INSTRUCTIONS TO PERFORM RECALL CAMPAIGN 168

2020 – 2023 Model Year; Travato 259G/GL

Dealer #7900 Part Kit-RC7900-23-768

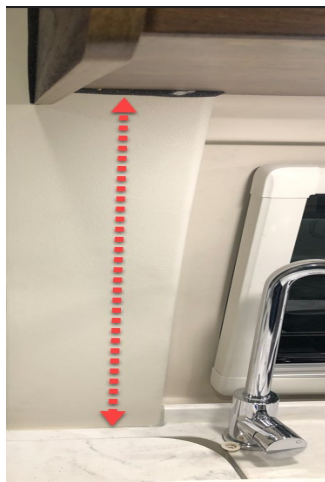
7. Locate carefree blue tooth module behind panel above the sliding door. Module location is towards the rear of the panel. Remove caps and fasteners to gain access.

Note: Model year 2020-early 2021 blue tooth module is located behind awning switch panel. Refer to sheet 11-13 for additional information.

Figure 2: BT12 and switch circuit

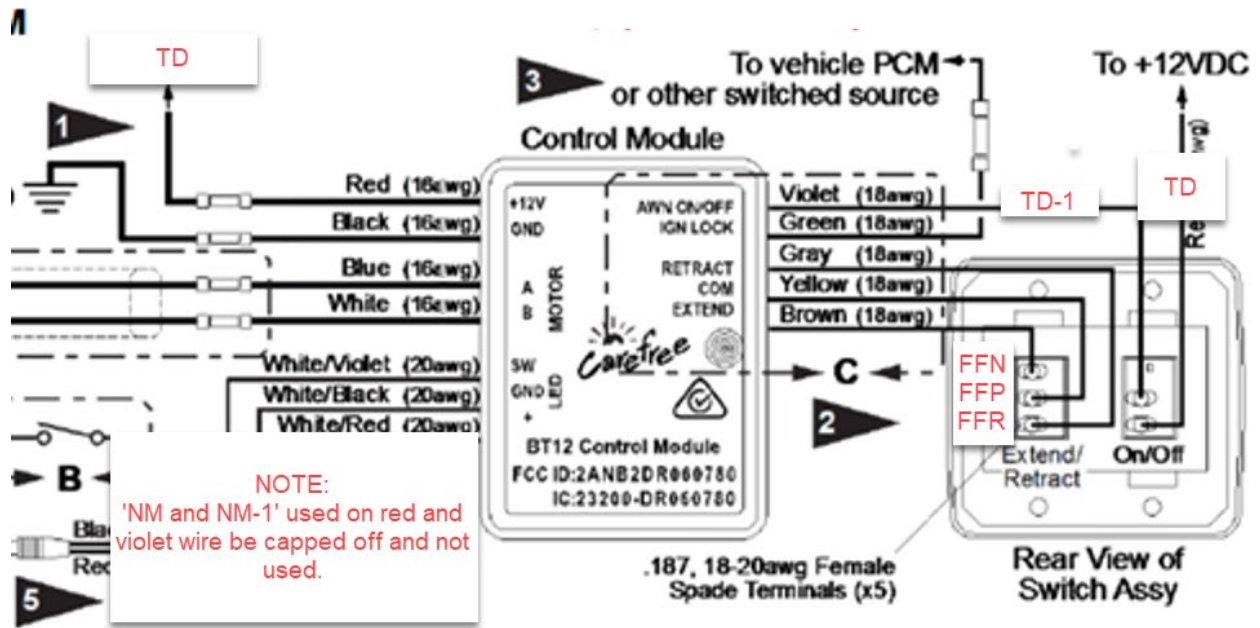
- Remove panel and find 15-pin connector on main harness. Locate (TD) in connector. Cut wire and connect (Y) splice ends to harness. Route wire from new harness to the plug.

- Remove (NM) wire from violet and Red on module. Connect new harness wires (TD and TD-1) to blue tooth module. TD to Red wire, and TD-1 to violet wire. See wiring diagram below:

NOTE: Cap off NM and NM-1 wire at module using butt connector from kit.

- Install Carefree switch and remaining two switches in plate. Wire Carefree switches per above diagram. Install switch plate to cabinet.

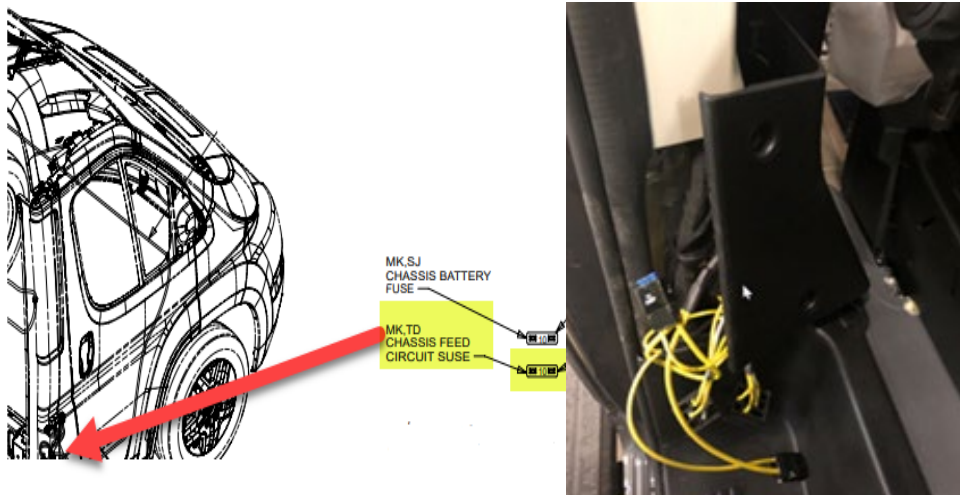
13. Locate 12v fuse panel. Remove 15-amp fuse and white out awning identification on plate for #6. Remove 'NM' wire from fuse box and tape it back to the harness

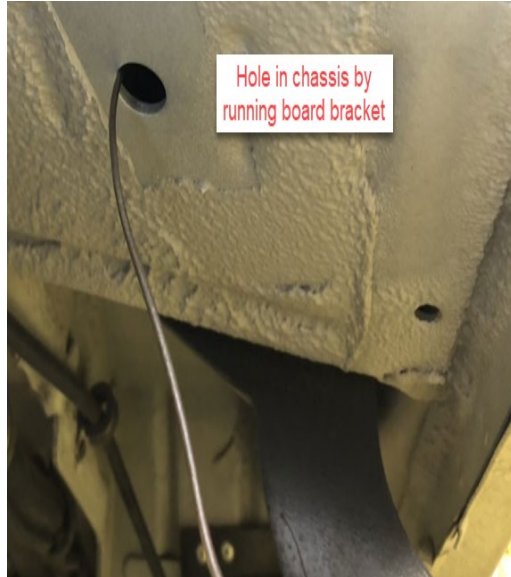
1. Locate BT module behind switch plate
2. From the parts kit, locate single strand wire in convoluted tubing approx. length 14' long.
3. Under galley find wire hole going though chassis next to relays.

4. Fish single strand wire through hole and locate wire run inboard of freshwater tank. Fish wire forward to access hole in frame. Secure wire as needed and seal holes with silicone.
